Marin County Flood Control and Water
Conservation District
**Corte Madera Creek Flood Risk Management
Project, Phase 1**
Final Environmental Impact Report
Volume 1: Comments and Responses to Comments
State Clearinghouse No. 2020080353

**Marin County Flood Control and Water
Conservation District
Corte Madera Creek Flood Risk Management
Project, Phase 1
Final Environmental Impact Report
Volume 1: Comments and Responses to Comments
State Clearinghouse No. 2020080353**

Figure 2-15 Alternative 1 Changes in Water Surface Elevation Year 2100, 25-Year Flood Event (Upper Corte Madera Creek)

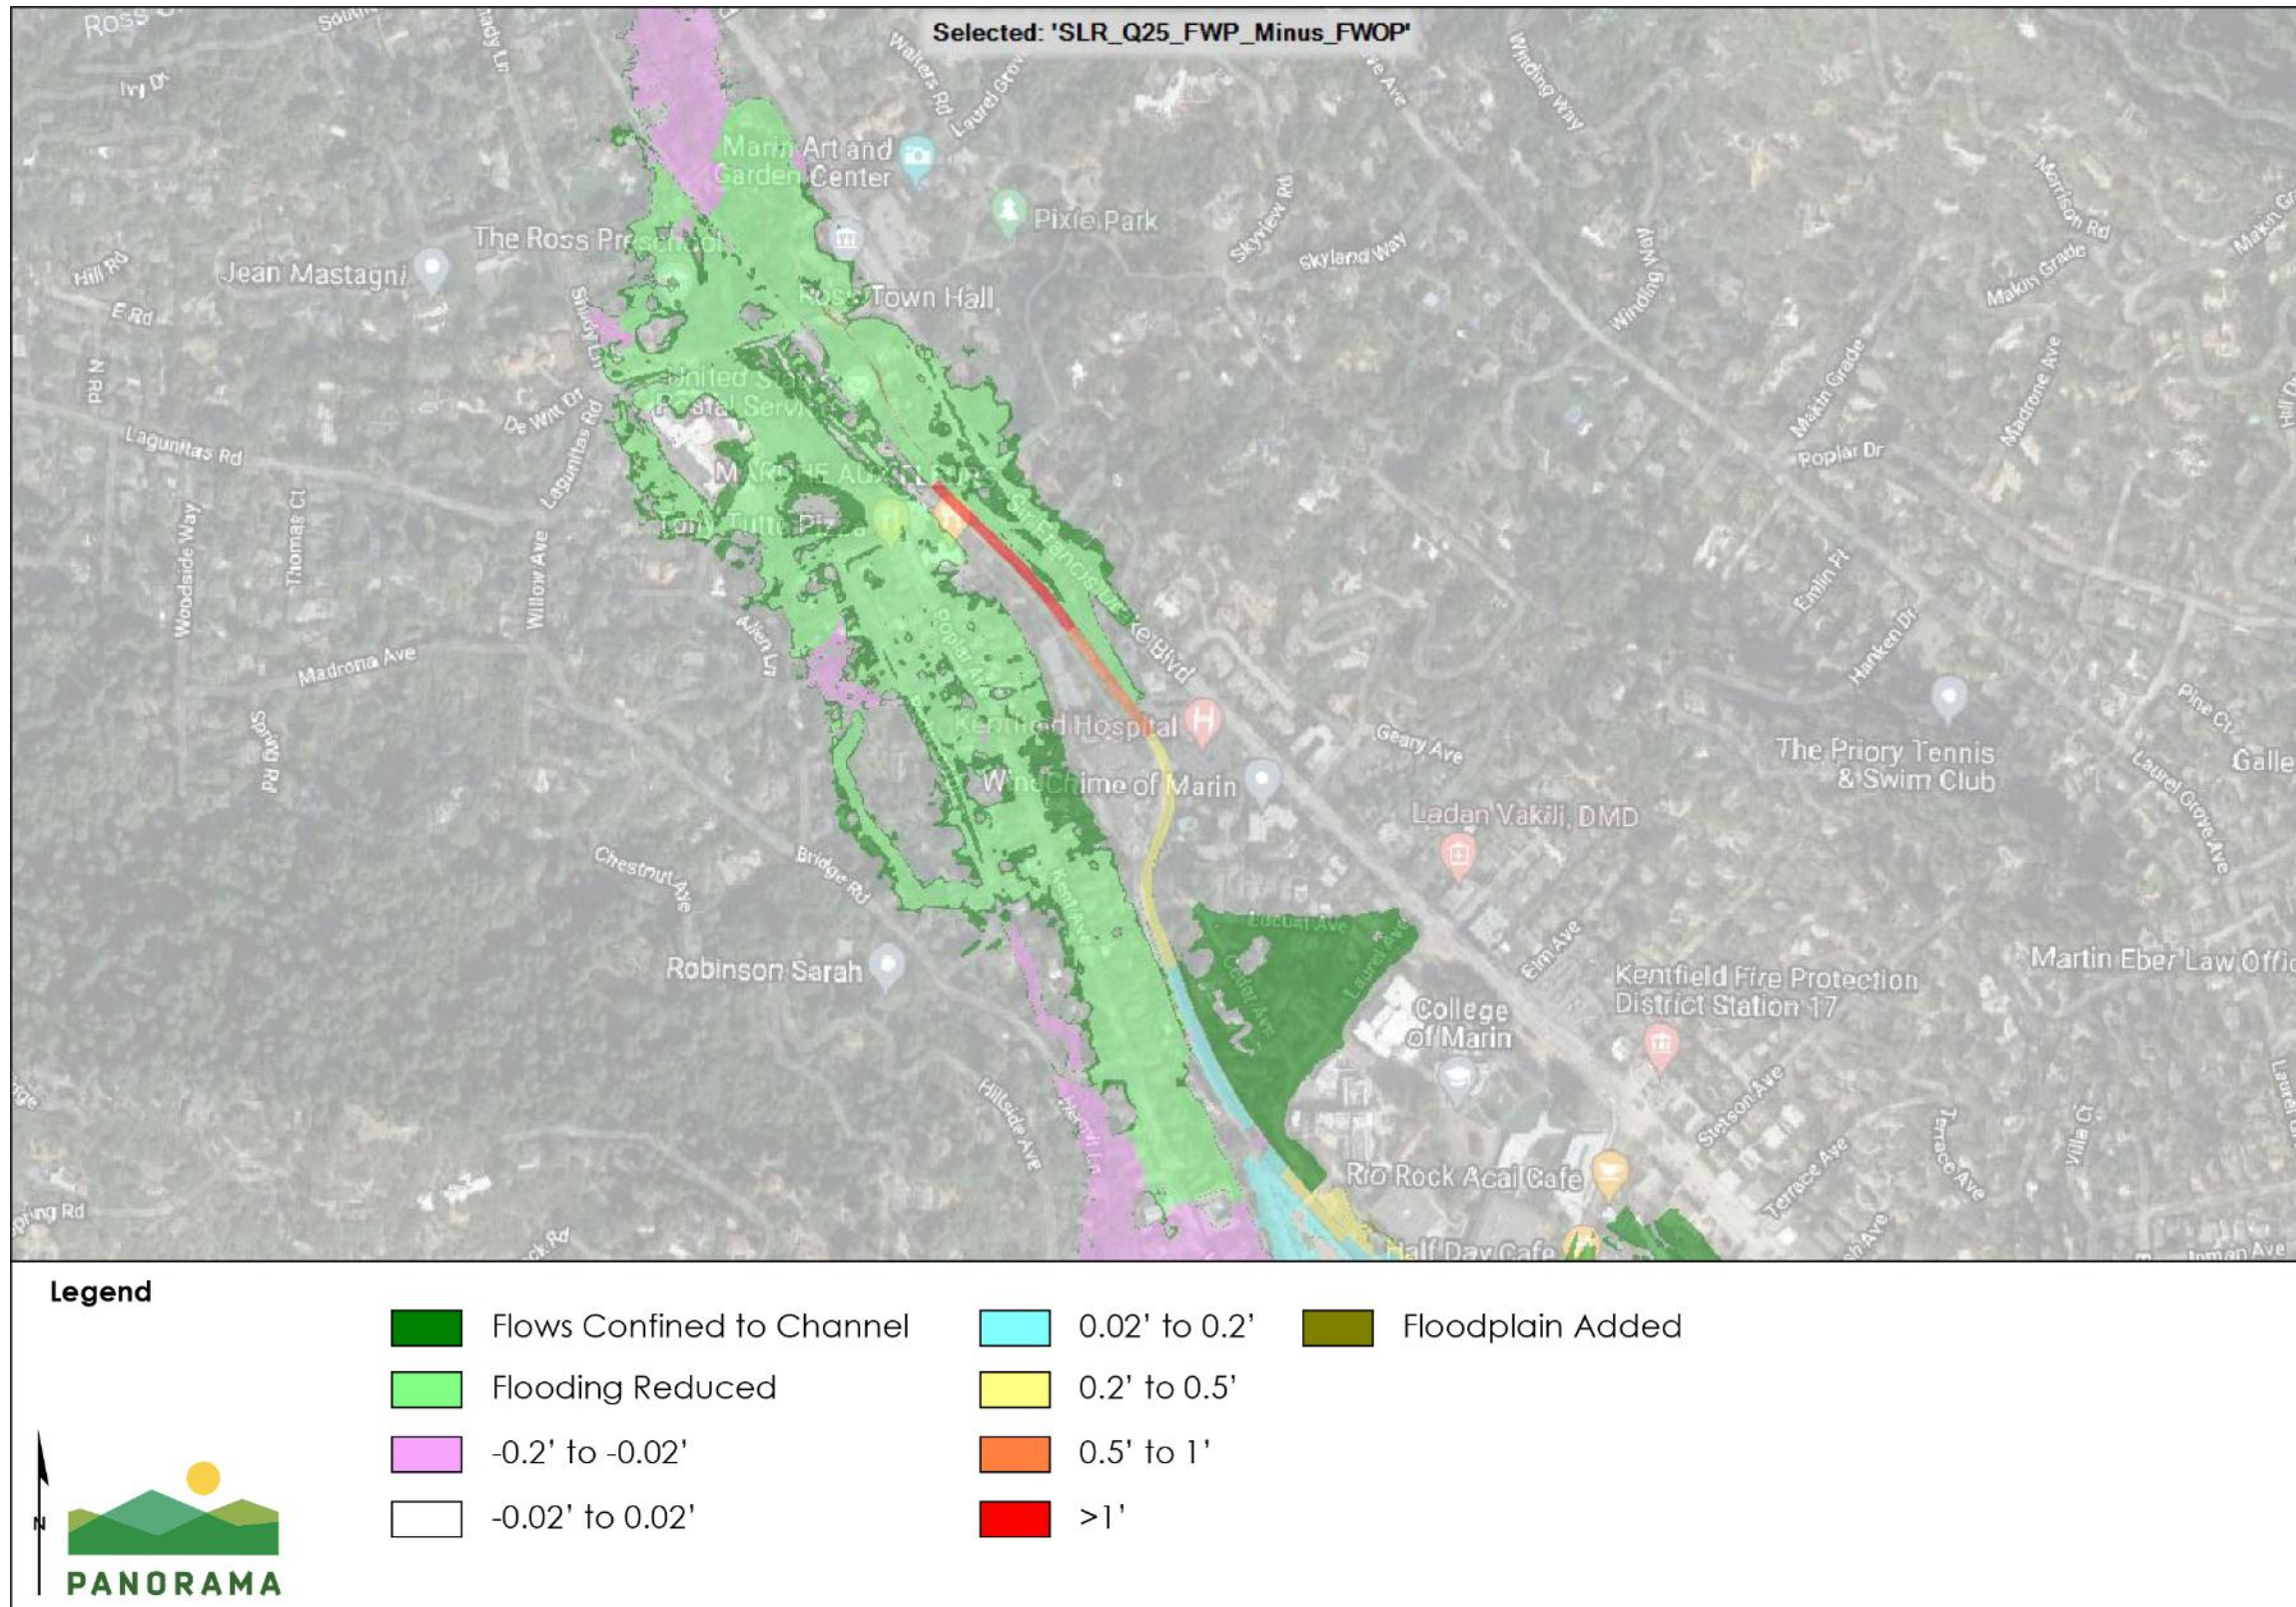
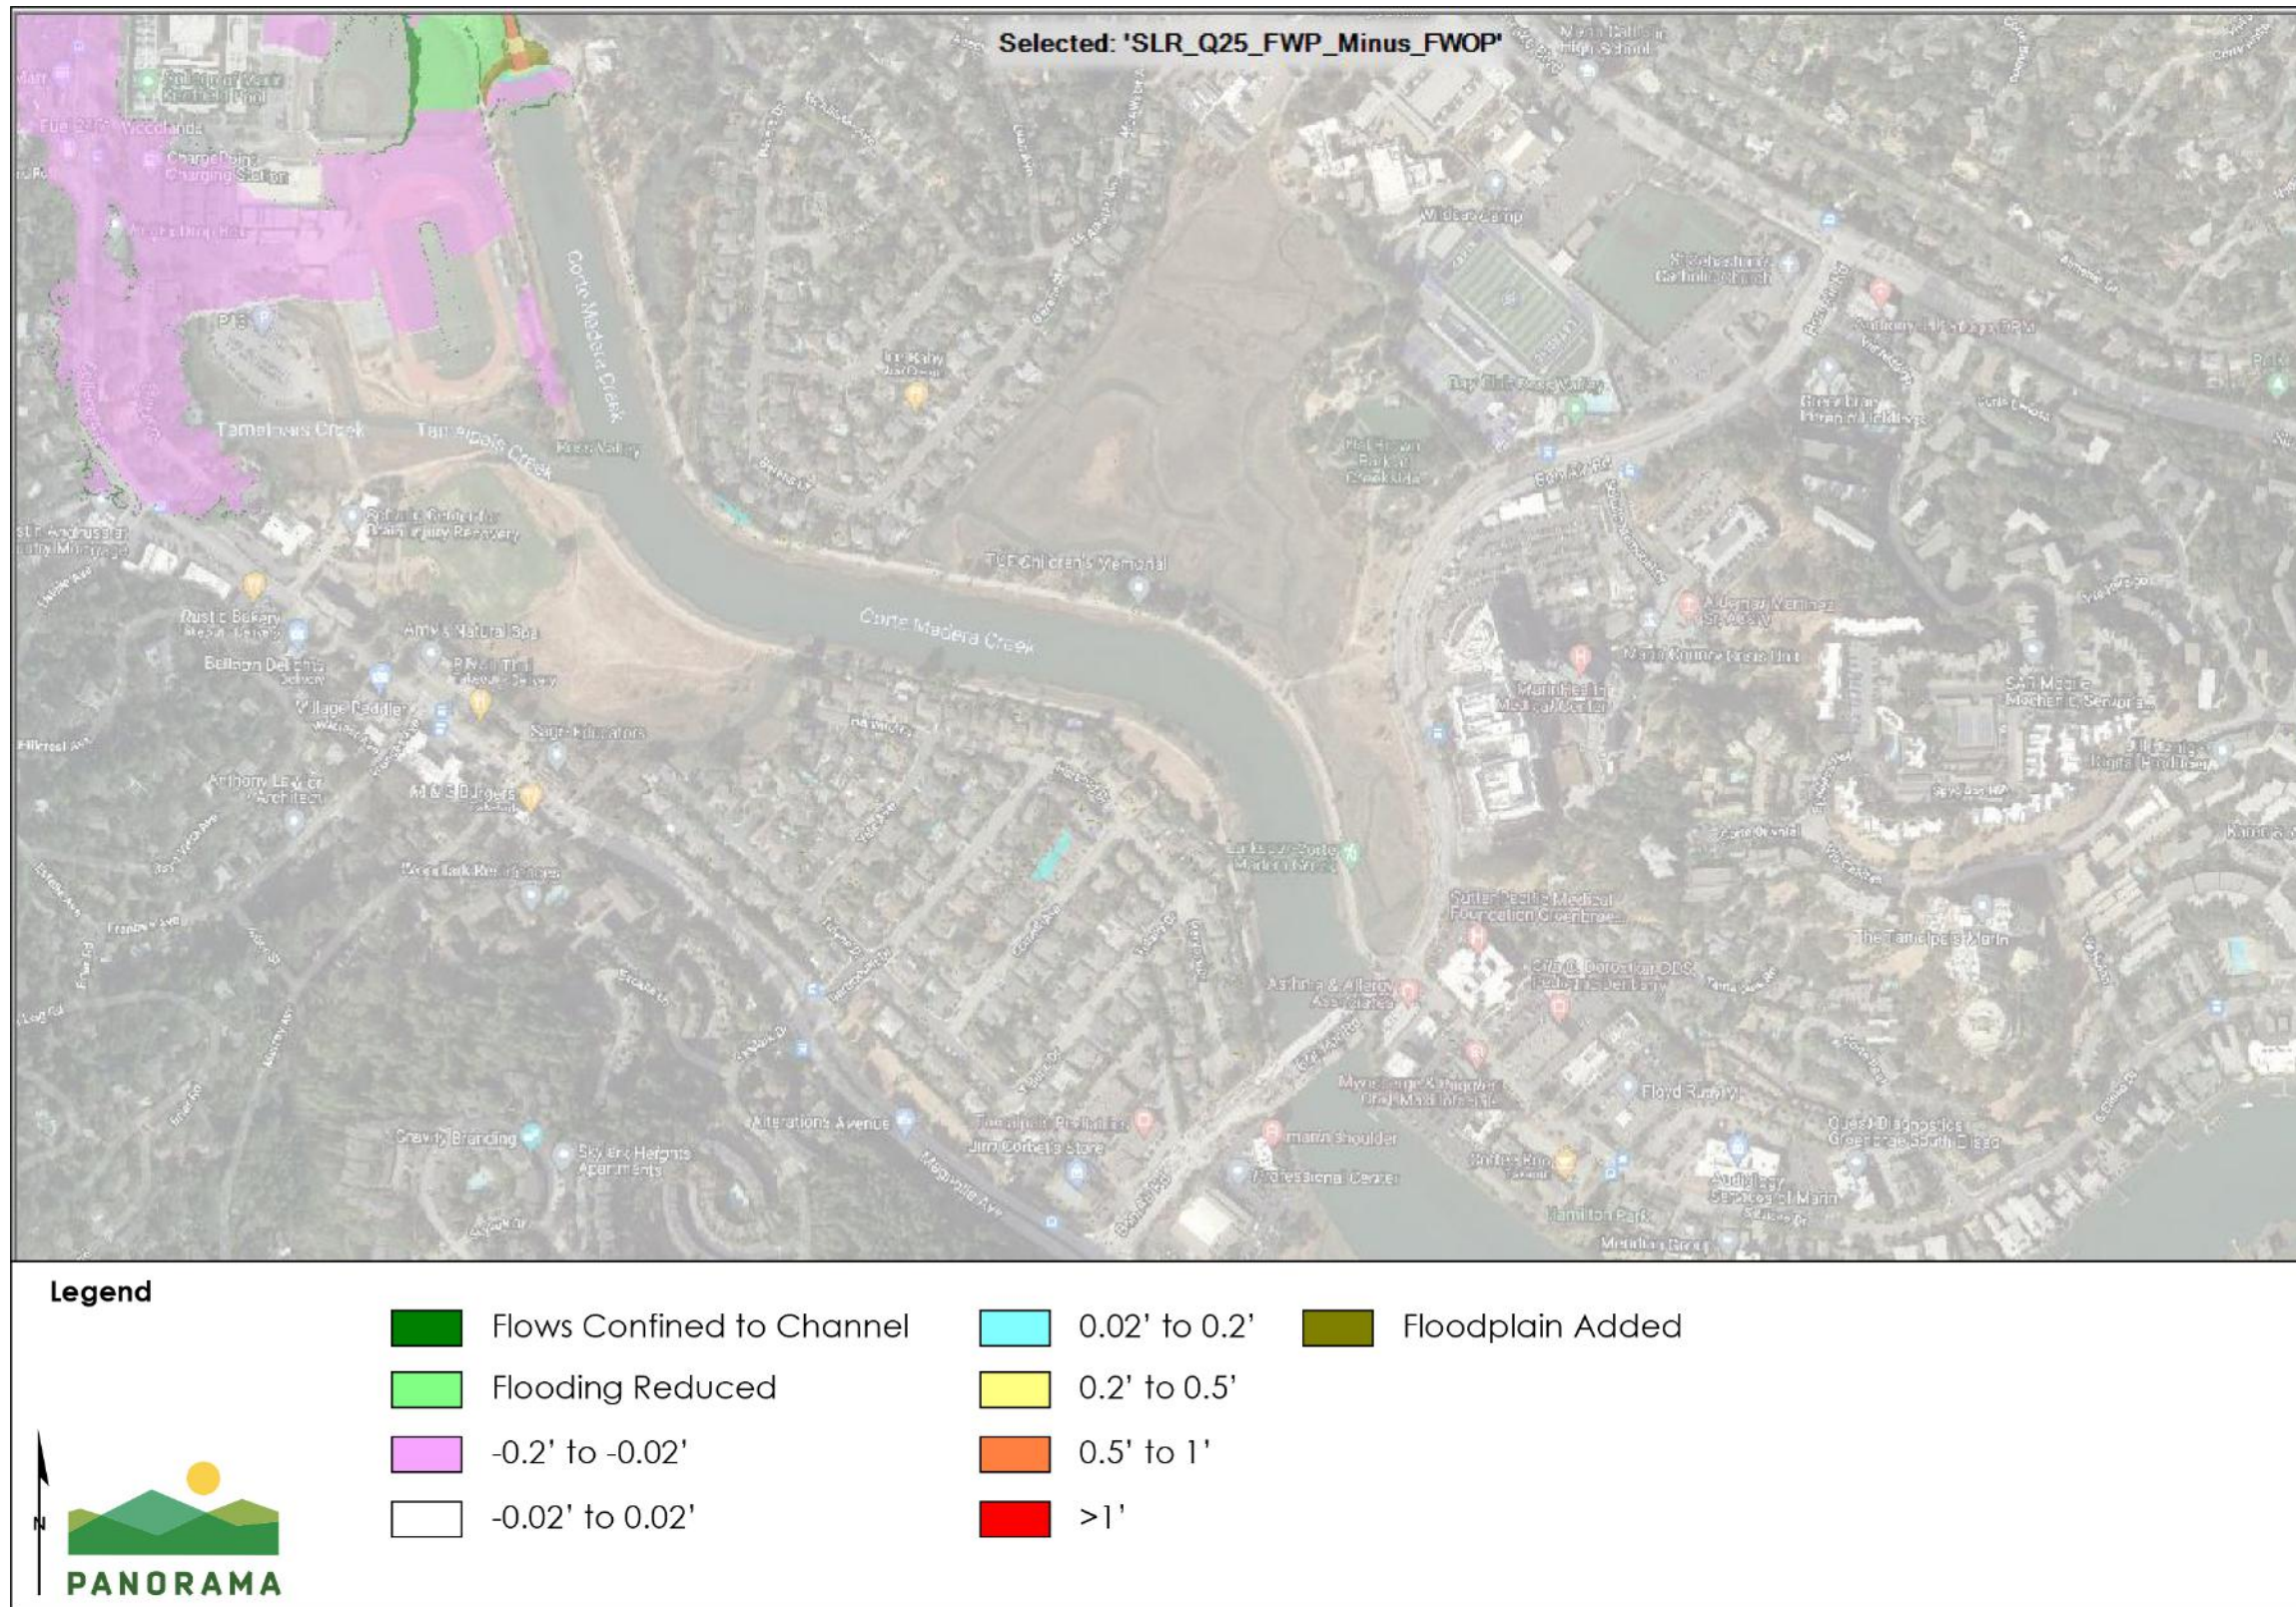
The geographic extent of the figures showing the changes in WSE differs from the figures included in the Draft EIR. The geographic extent of the figures was expanded to show areas downstream from Unit 2 in response to comments from the City of Larkspur. As discussed on page 3.9-39 in the Draft EIR, a threshold of 0.2 foot (2.4 inches) was used for determining whether a potentially significant increase or decrease in WSE would occur at any structure. The 0.2-foot threshold is a reasonable level of precision for evaluating flooding impacts, considering the standards for accuracy and precision associated with hydraulic modeling.

Figure 2-1 through Figure 2-6 show the Alternative 1 changes to the WSE and reflect the difference in WSE between the Existing Condition Without Project and Existing Condition With Alternative 1 scenarios under a 10-, 25-, and 100-year flood, using the updated modeling for the 60 percent design. Figure 2-7 through Figure 2-12 show the Alternative 1 changes to the WSE under for the future condition scenario, and reflect the difference in WSE between the Future Condition Without Project and Future Condition With Alternative 1 under the 10-, 25-, and 100-year flood conditions. The assumptions used in the future condition modeling are described on pages 3.9-35 through 3.9-37 in Section 3.9 in the Draft EIR and are supplemented by the model updates described above. Figure 2-13 through Figure 2-18 show the Alternative 1 changes to the WSE under a “high-emissions likely” sea-level rise scenario, to reflect 2100 projected sea-level rise based on the 2018 Update of the State of California Sea-Level Rise Guidance (California Ocean Protection Council, 2018). Figures 2-13 through 2-18 reflect the difference in WSE between the Year 2100 Future Condition Without Project and Year 2100 Future Condition with Alternative 1 scenarios under the 10-,25-, and 100-year flood conditions.

Areas shown in the figures as “Flows Confined to Channel” are areas that are currently flooded by Corte Madera Creek, which are predicted to no longer have flood inundation from Corte Madera Creek overtopping after Alternative 1 is implemented. Areas shown in the figures with “Flooding Reduced” are areas with reduced flood inundation (greater than 0.2 foot) from creek overtopping after Alternative 1 is implemented. The change in WSE shown on the maps reflects a comparison between WSE without implementation of Alternative 1 and the WSE after implementation of Alternative 1 for each modeled scenario.
